**From:** Sophie Martin <campaigns@good.do>  
**Sent:** Sunday, 15 October 2017 7:13 AM  
**To:** DPE CSE Information Planning Mailbox  
**Subject:** Submission to WestConnex New M4/M5 EIS, project number SSI 16\_7485

Attn: Secretary, re: WestConnex M4/M5 EIS, Project Number SSI 16\_7485.

**SUBMISSION OF OBJECTION TO WESTCONNEX M4/M5 LINK EIS.** I am deeply concerned about, and strongly object to this proposal in its entirety and urge the Secretary of Planning to advise the Minister to refuse the application on the grounds below. NSW Planning must require the Proponent to properly and adequately address the impacts set out below which are not adequately addressed in the EIS. NSW Planning must reject this EIS and instead recommend to the NSW government that there should be an independent review of WestConnex before more billions are spent and more residents' lives are damaged.

Figure 2 - Figure 6-21 Indicative Rozelle civil and tunnel site (C5) and Victoria Road civil site (C7) layout

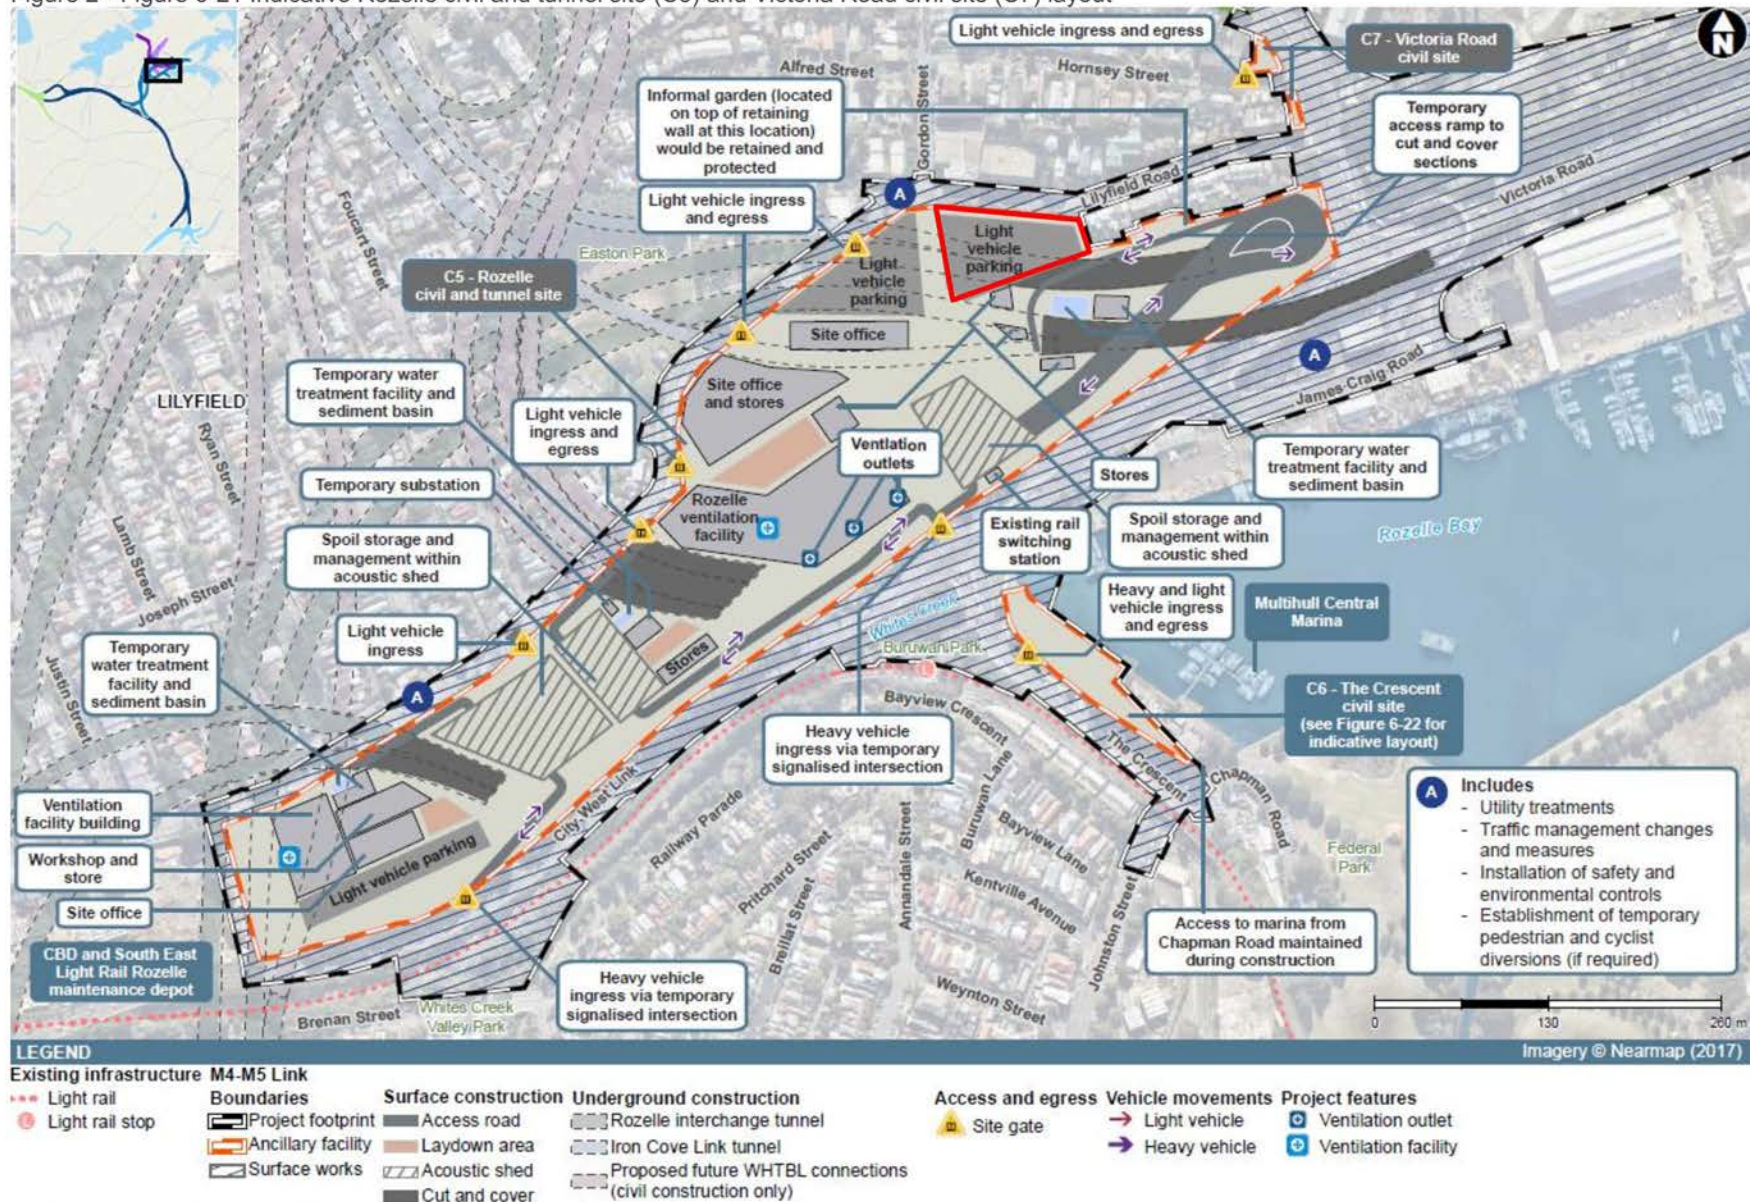
The proposed acquisition of the subject property is in direct contradiction to the Project's objective of minimising the impacts associated with acquisition of residential and commercial properties on communities and it is unnecessary from a project delivery and operation perspective.
